Planning Memorandum

From: Lori Johnson, City Planner

Re: **2570 Delaware Avenue – Major Site Plan Review, Conditional Use Permit and Variances**
WSB Project No. 024203-000

SHEET NAME
TREE REMOVALS
SHEET NUMBER
L001

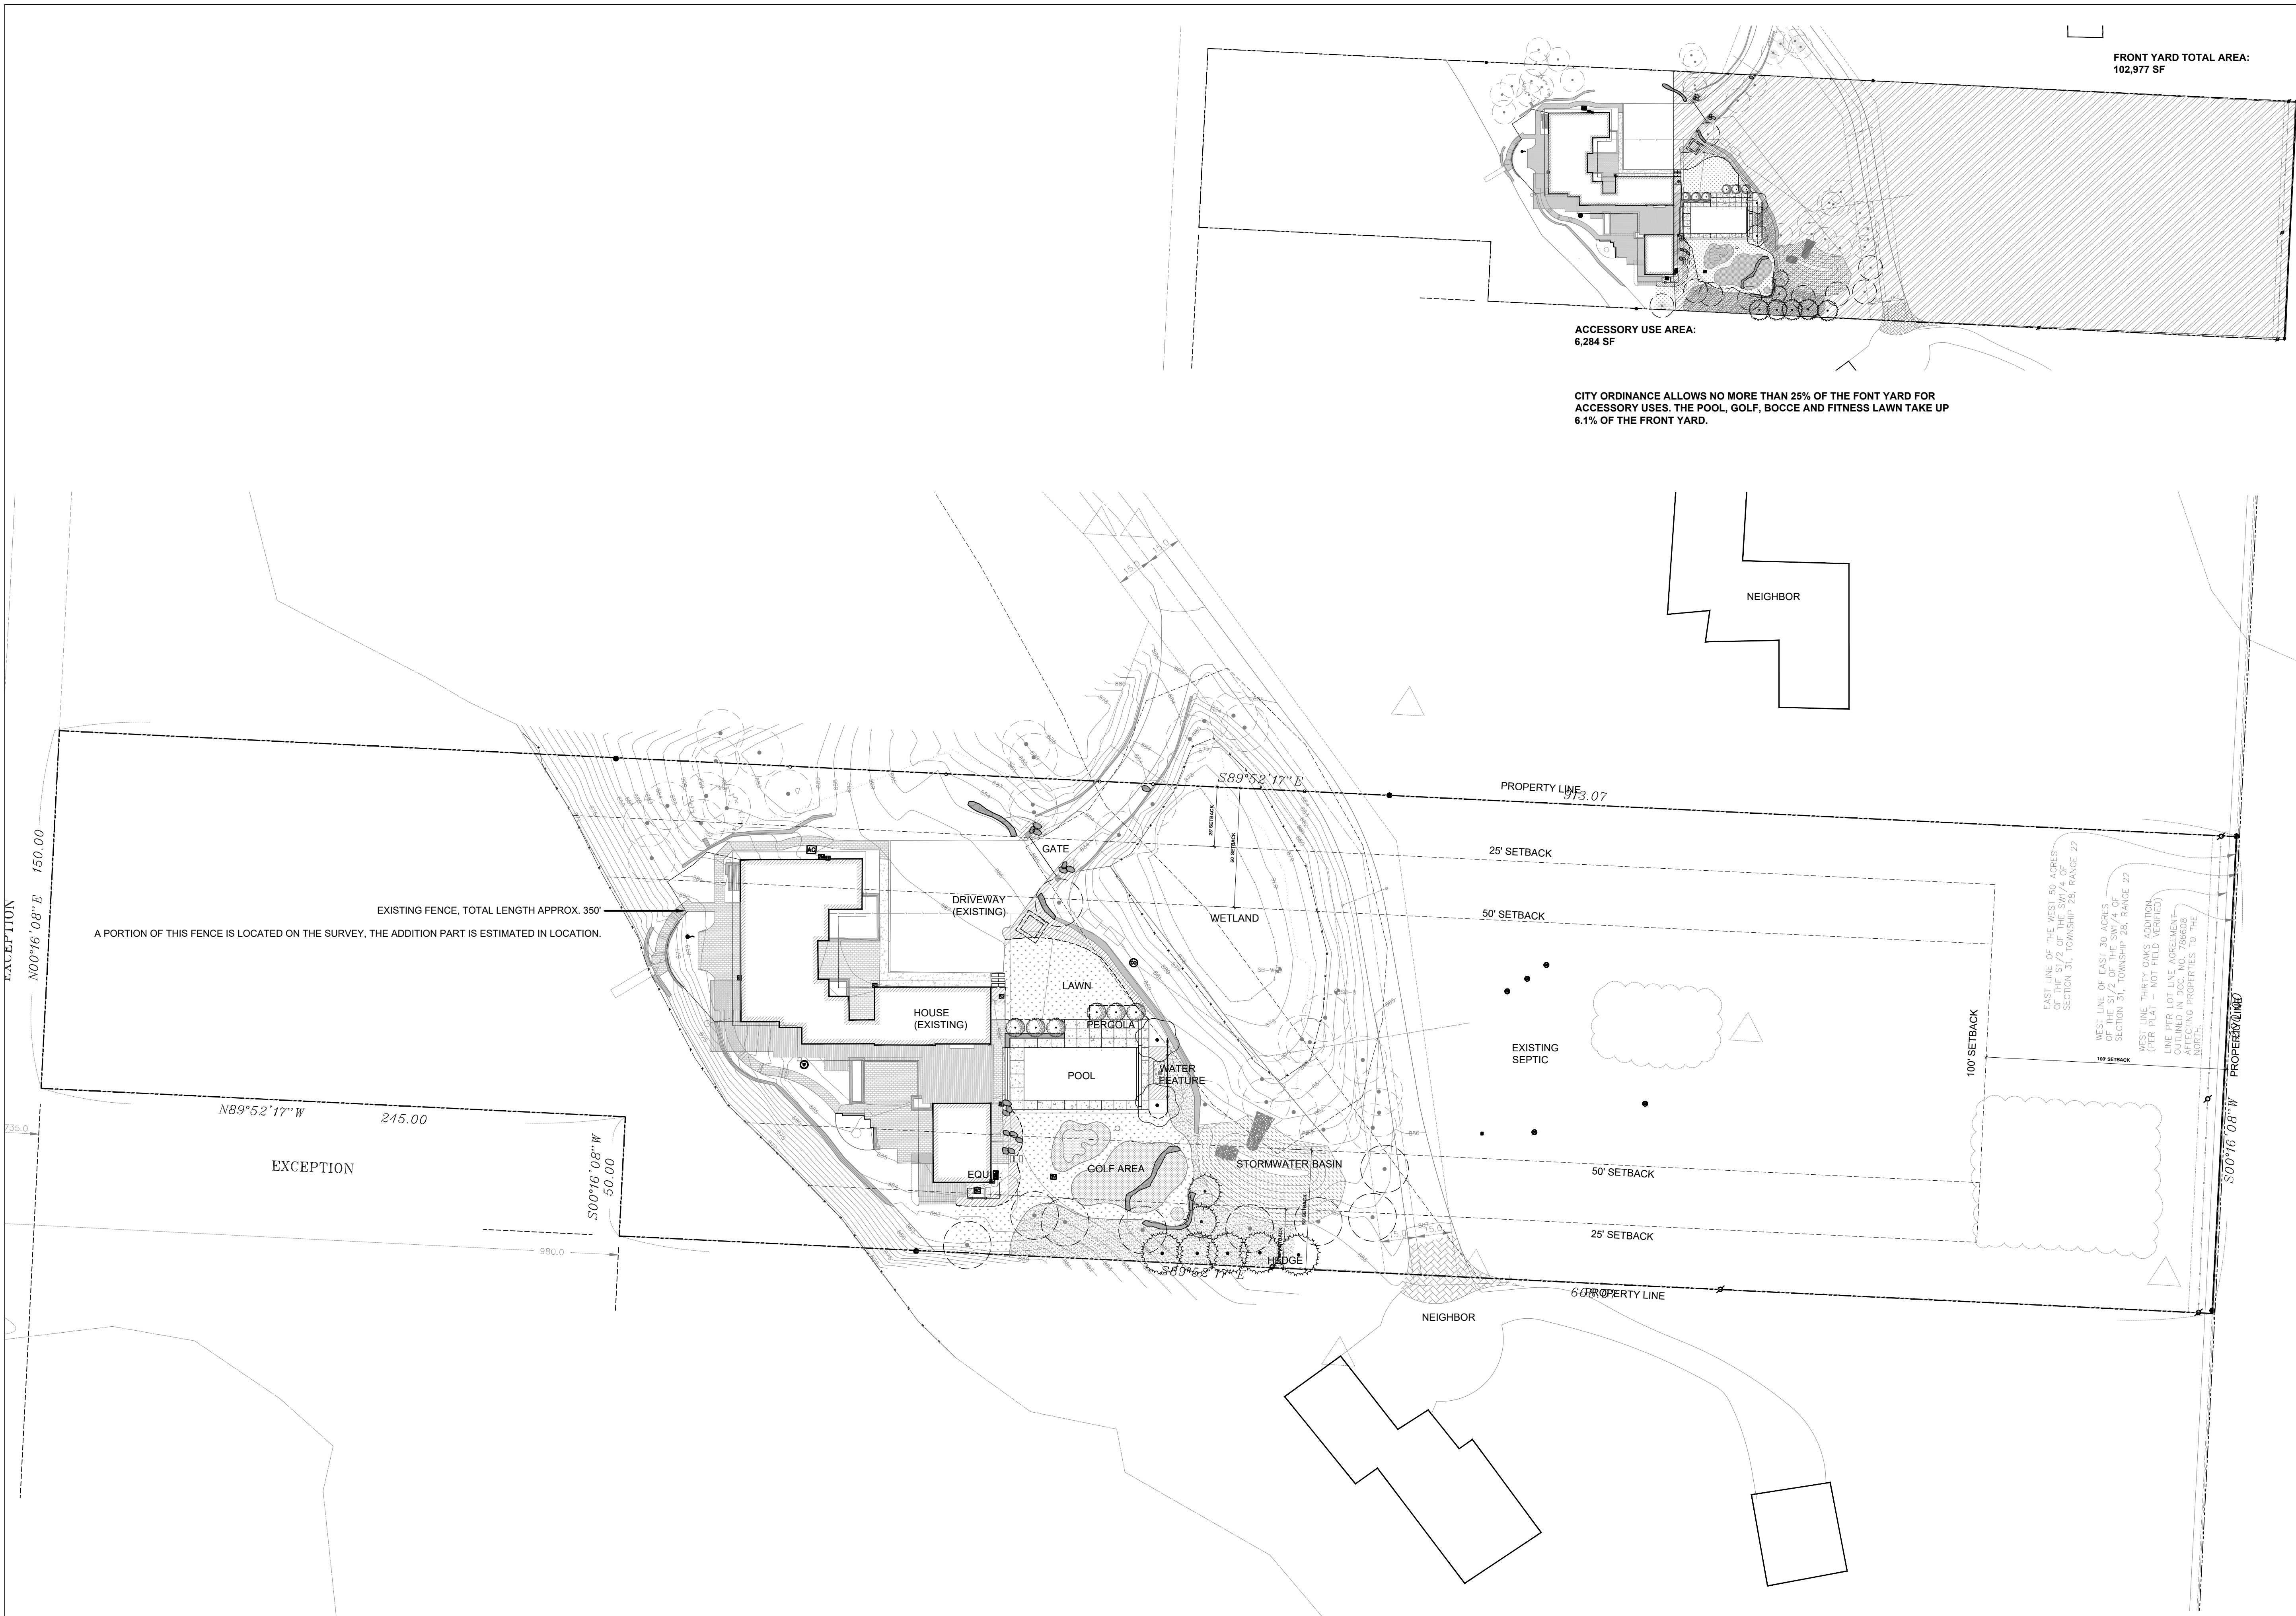
SYMBOL CODE BOTANICAL NAME
DEMO X DEMO TREE
NOTE 6/3/2024
ON-SITE EVALUATION, DISCUSSION WITH THE EASTERN
NEIGHBOR, AND THE PLANNING COMMISSION RECOMMENDATION
IS TO KEEP THE ONE OAK TREE INDICATED ON THE PLAN IN
GREEN.
PLEASE NOTE REQUEST TO REORIENT EXISTING BOULDERS

INDICATES TREE TO REMAIN, AS DETERMINED WITH ON-SITE EVALUATION AND RECOMMENDED BY PLANNING COMMISSION

SHEET NAME
SITE ORIENTATION PLAN

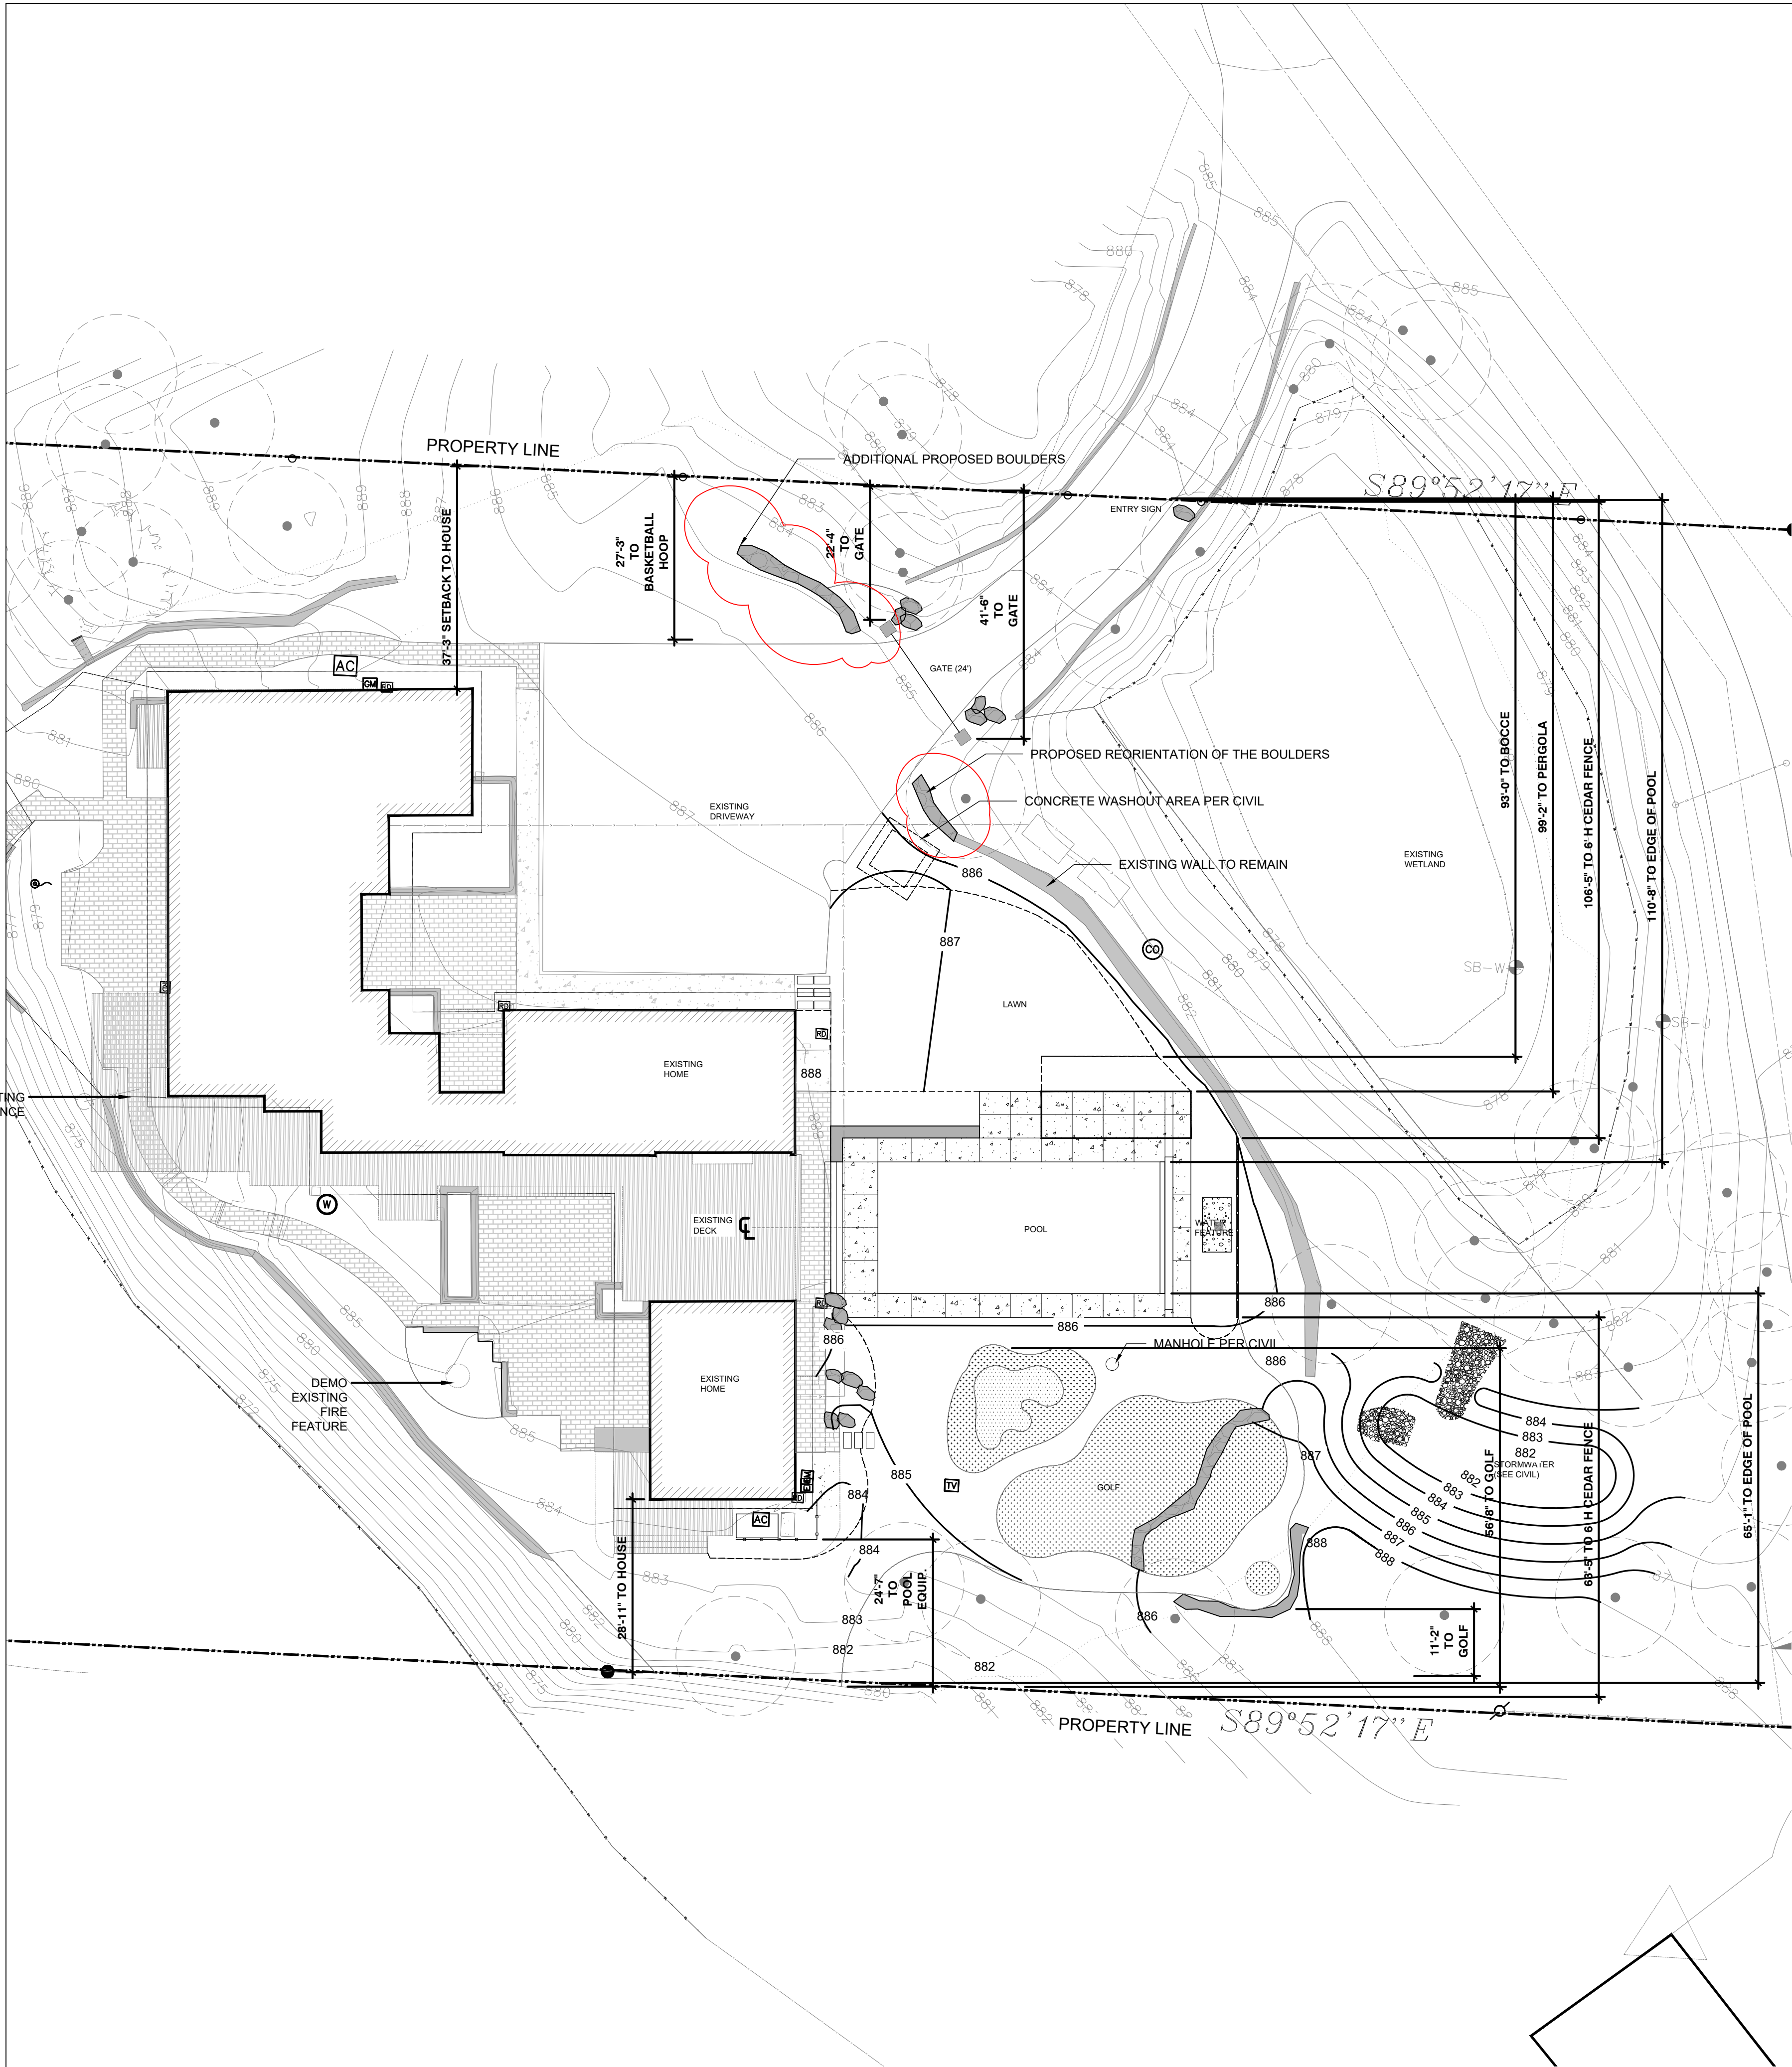
REMOVE SMALL PORTION OF BOULDERS AND REORIENT TO CREATE A MORE GRACIOUS CURVE (RED AREA INDICATES NEW LOCATION)

NOTE 6/3/2024
- PLEASE NOTE REMOVAL OF TREEHOUSE.
- PLEASE NOTE REMOVAL OF FITNESS EQUIPMENT.
- PLEASE NOTE, AS WAS ON PLANS EARLIER, THE SCREEN FOR THE POOL EQUIPMENT, THIS HAS BEEN SLIGHTLY MODIFIED SINCE THE LAST SUBMISSION DUE TO CONVERSATION WITH POOL EXPERT ON BEST LOCATION FOR EQUIPMENT.
- PLEASE NOTE REQUEST TO ADD ADDITIONAL BAND OF DECORATIVE BOULDERS.

EXISTING CONDITIONS AT SALE OF PROPERTY

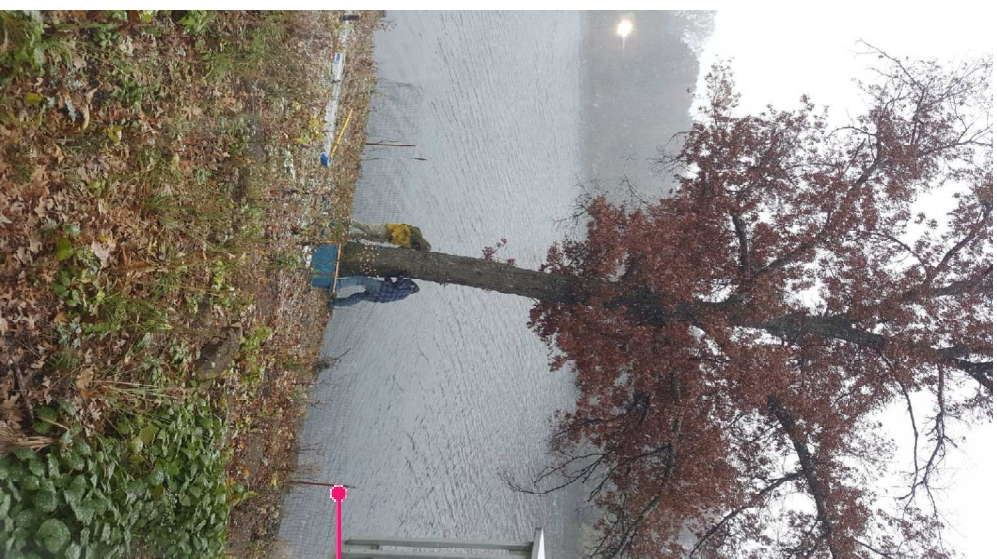
PLEASE CONSIDER THE SAFETY REQUIREMENTS AND CHALLENGES OF A HOUSE SO CLOSE TO THE LAKE. THIS STRUCTURE IS CLOSER TO THE LAKE THAN ANY OTHER ON THIS LAKE.

— BOULDER WALL ADDED TO STABILIZE SLOPE (ADDITION AND UPPER PATIO WERE APPROVED) FENCE ADDED BECAUSE THE DROP WAS OVER 30"

EXISTING SHORELINE FENCE

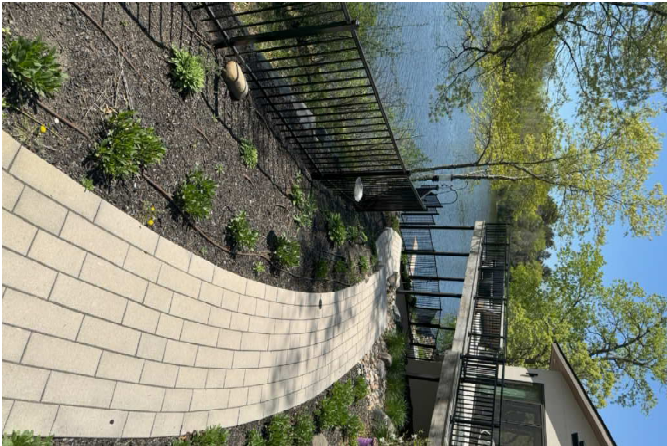
FENCE IS REQUIRED BY BUILDING CODE FOR FALLS OVER 30" OR GREATER, THE BOULDER WALL HELPS RETAIN GRADE AND STABILIZE THE SLOPE
